BendPak two post vehicle lifts – safety issues relating to locking mechanisms

Health and Safety Executive - Safety alert	
Department Name:	Field Operations Division
Bulletin No:	FOD1-2018
Issue Date:	28 November 2018
Target Audience:	All users of BendPak two-post vehicle lifts, Motor vehicle repair and associated industries, Suppliers
Key Issues:	<ul style="list-style-type: none"> • There are up to 1700 or more BendPak two post vehicle lifts in use throughout Britain with potential faults • The lifts present a serious risk of a vehicle falling from the hoist with the potential of causing death or serious injury • Evidence obtained during an on-going investigation of a fatal incident has revealed concerns with the design, manufacture and supply of the BendPak two-post lifts • All users of BendPak two-post vehicle lifts should check the arm restraint gear on their lift and, if affected, take immediate action to replace
Health and Safety Executive - Safety alert

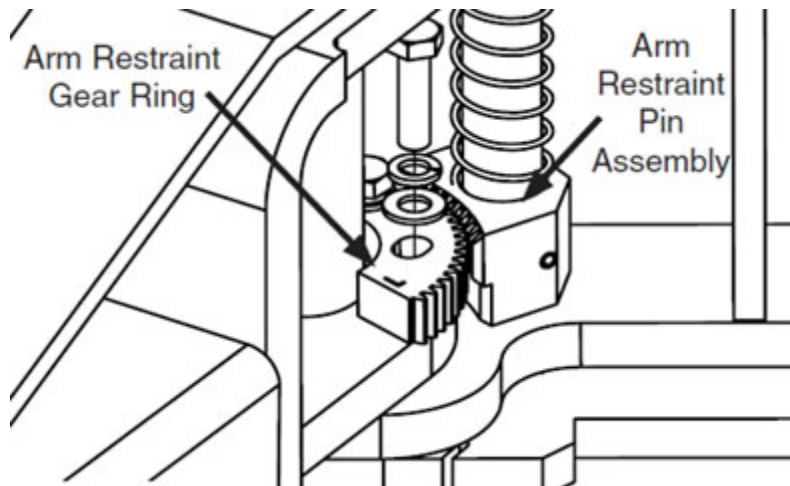
An unknown number of BendPak two-post vehicle lifts have been supplied with arm restraint gears which allow complete disengagement from the arm locking mechanism, located on the carriage of the vehicle lift.

Also, in some of the lifts, the arm restraint gears are manufactured from a material that is insufficient to withstand the forces which satisfies the testing required by the harmonised standards relating to vehicle lifts. The current standard is BS EN 1493:2010.

The manufacturer has now redesigned the arm restraint gear. The new design is a machined part using a grade of steel which was found to be suitable when tested by the manufacturer. The gears now have circular rather than oval holes and a wider cross section which prevents disengagement.

- oval holes
- a narrow cross section
- an internal diameter much larger than the pin that the arm swings on.
- the appearance of being sintered or cast, rather than machined

If the lift does not have the newly designed arm restraint gear **take immediate action to replace** it. Users should contact their supplier, or the manufacturer, to get replacement parts. The gears should be steel, machined with circular holes. They should sit properly against the pin that the arm swings on without visible clearance.
